Dannat House, Templewood Avenue

Title Proposed Section A-A Drawing No. 1803-PL-20

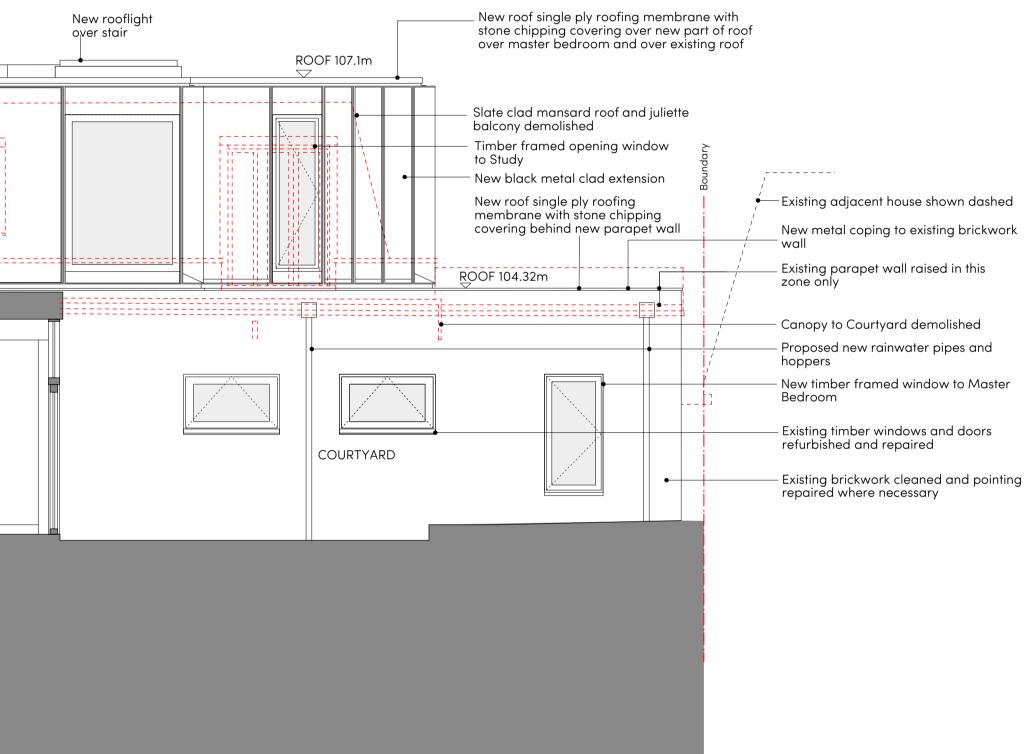
Rainwater pipes added so that water from 1st floor extension and Bedroom I drains to courtyard rather than to front of house (to avoid new drainage run in RPA).
